Work Order ID 126770 -2

Item Name: Clip

ENGINEERING CHANGE NOTICE NL 04510

From: Jean-Luc Menard
Sent: November-24-14 7:37 PM
To: Linda Lacelle
Cc: 'David Duval'; Marc Bellavance; Sylvie Boucher (sboucher@dartaero.com); Holly Menard
Subject: FW: 647.4113/647.4112 FLAT PATTERN ERROR
Attachments: 647.4112-4113_Flat_Pattern.pdf

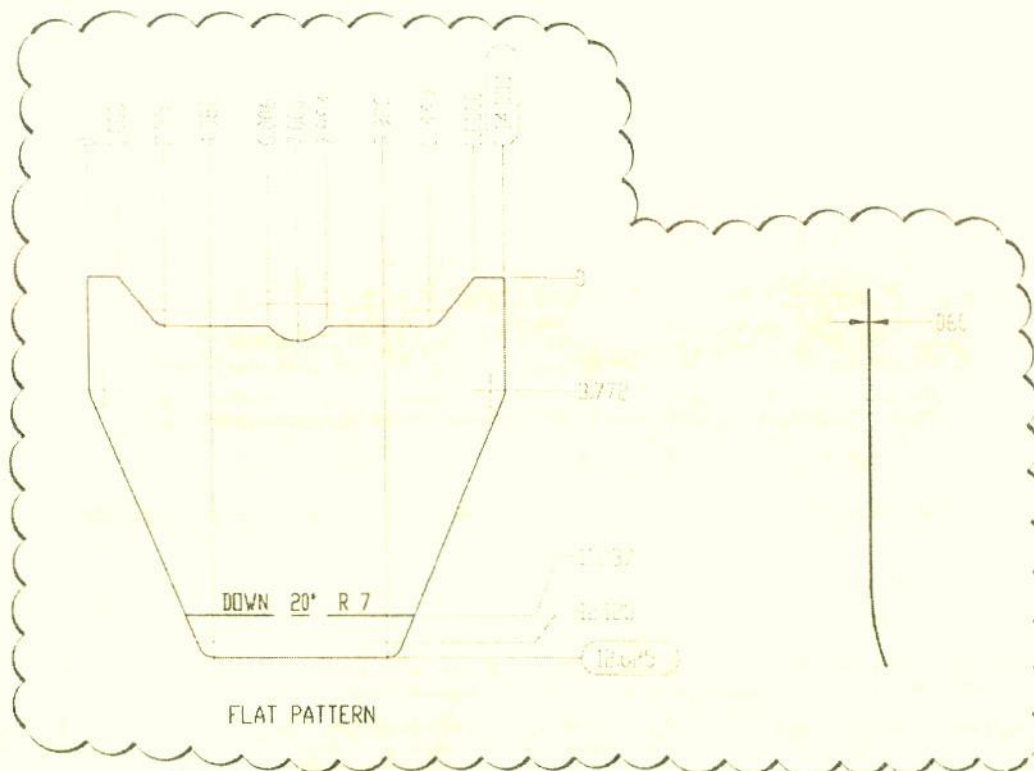
REASON: MODIFIED DOUBLER.

SHEET 1, ZONE C2 IS:

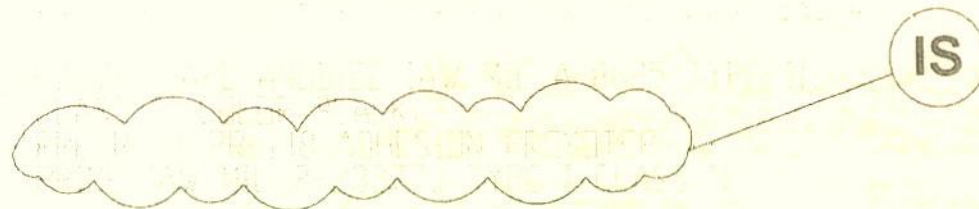
APICAL INDUSTRIES, INC.	ENGINEERING CHANGE NOTICE NO. 02866				SHEET 1 OF 1	
	DWG NO. 647.4100	REV: N/C	PREPARED BY R. ROSANO	DATE: 05/05/10	EFFECT ON DWG ☐ INC. ☒ UNING	
	DWG TITLE: SHEET METAL					
	APPROVED BY	ENGR <i>[Signature]</i>	MFG <i>[Signature]</i>	QC <i>[Signature]</i>	EFF: CURRENT ORDER	
TRANSACTION CODES (TC) A-ADD C-CREATE R-REVISE D-DELETE		REASON: CHANGED PRETREATMENT CALLOUT

SHEET 1, ZONE A1 IS:

647.4113 SHOWN
647.4112 OPPOSITE

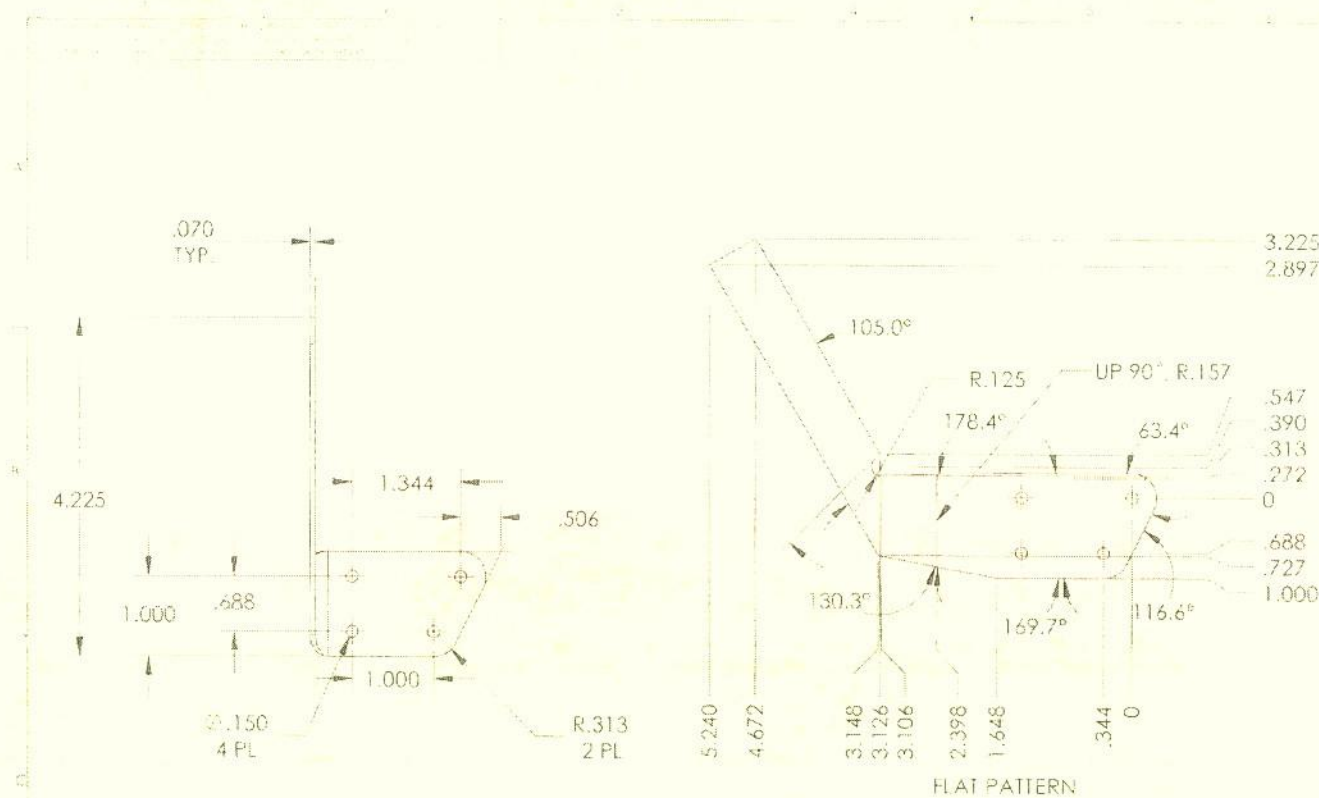
Hi Pablo,
There seems to an error in the flat pattern on the dwg, Marc Bellavance had a quick look and came up with the file attached.

The flat pattern is acceptable. We'll need to get the drawing updated.

FLAT PATTERN

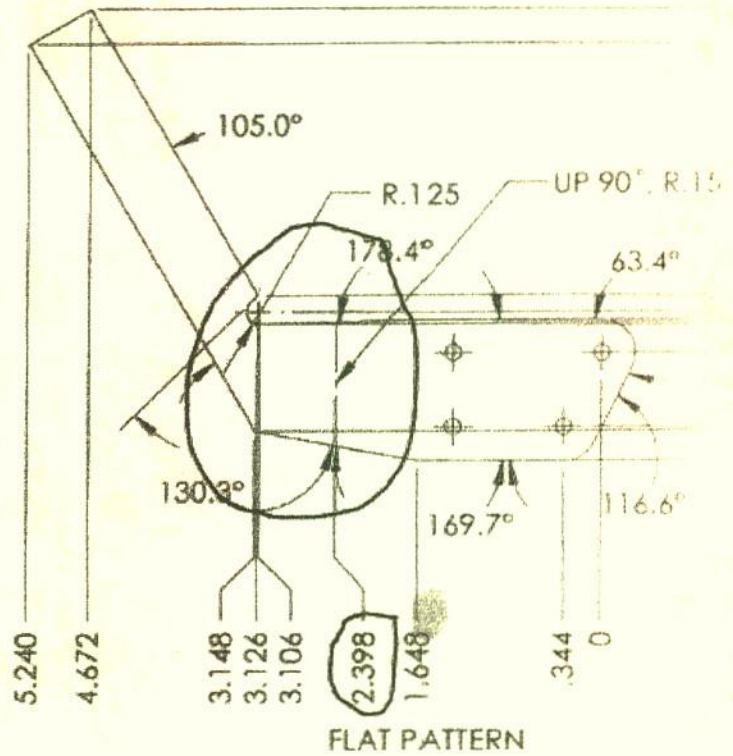
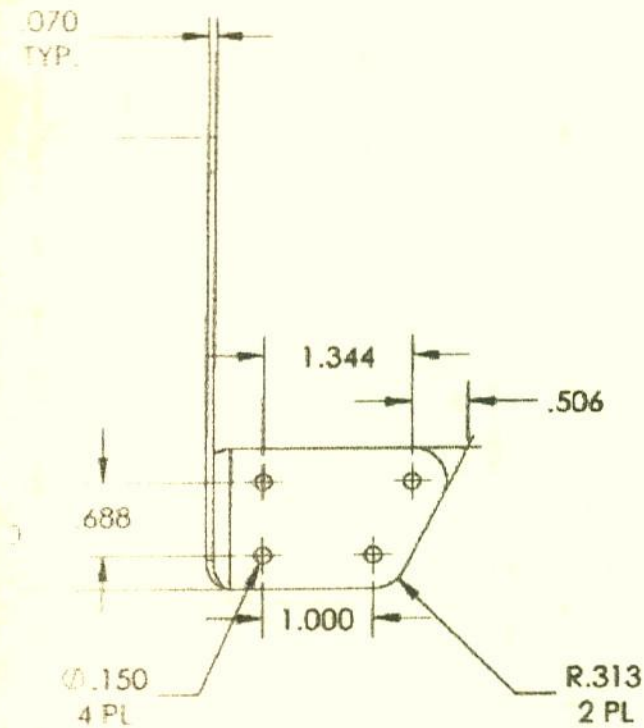
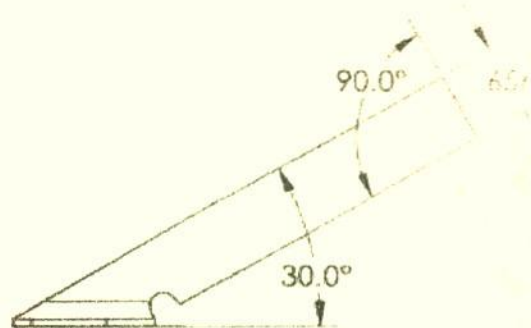
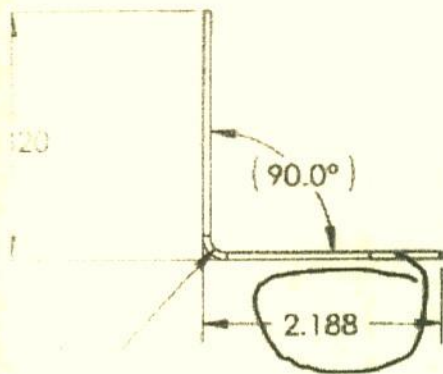
What is happening is the flat pattern is too long in the mid section(see snip below).

Let me know if you need me to issue an ecr for this one, and if we can continue with Marc's updated flat pattern.

If you agree with Marc's pattern, I will attach the email to the w/o so we can continue production.

Hi Linda,
New Flat pattern has been programed and is on the network.
See below for Pablo's e-mail to attach to the w/o.
Attached is a temporary dim sheet to reflect the new dimensions.
JL

Tyler, can you please update the drawing as soon as possible?
